Tree Conservation Report Addendum submitted as
Partial Requirements for a Site Plan Control Application,
August 25, 2026

Application: D02-02-26-0012 (Minor ZBLA) and D07-
12-26-0014 (SPC)

TREE CONSERVATION REPORT ADDENDUM 4.0

71 Russell Ave

Figure 1: Image of updated site plan with the surveyed location of tree 10 and proposed notch. The static root zone is shown in blue, the proposed excavation in green, and the old wooden wall in the hashed blue line

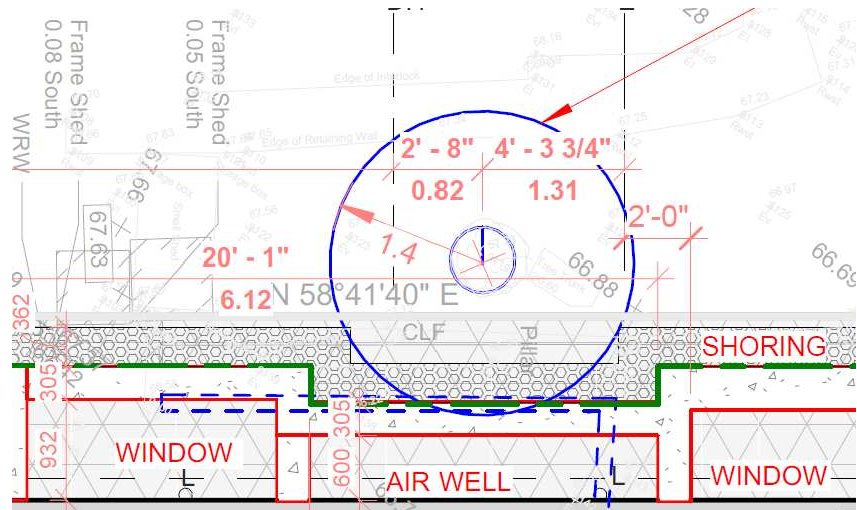
o The static root zone of a tree is defined by the International Society of Arboriculture Best Management Practices as the tree's diameter times three. For a 45cm diameter tree, the static root zone would be 1.35m. No lateral cut to a root shall be made in this area without risking instability. The TCR states the wooden structure on site was 40cm from the L bend and 90 cm to centre of the tree. The excavation to install the shoring is stated as being 20 cm closer to the tree than the wooden wall. This does not align with the ISA BMPs that suggest no roots should be cut in a tree's static root zone. The TCR needs to outline what the static root zone for this tree is and how far excavation/root pruning would need to be from the tree to avoid compromising this trees health and stability. This must align with the civil plans.

The project team has redesigned the wall to include a notch around the tree that relocated the shoring and proposed retaining wall to follow the path of the previous wooden wall, which followed the extent of the roots on the subject property immediately adjacent to the tree. The image below shows the updated site plan that includes the surveyed location of the tree and the location of the old wooden wall (extent of roots) as the dashed blue line. The green line represents the extent of excavation via shoring. This notching also demonstrates how the roots beyond the elbow of the old wall that will be severed as part of the shoring installation are outside of the static root zone, which is defined as three times the diameter of the tree. Although the diagram shows the measurement of the static root zone from the centre of the tree, the excavation is still outside of the static root zone if measured from the edge of the tree (an additional 23 cm).
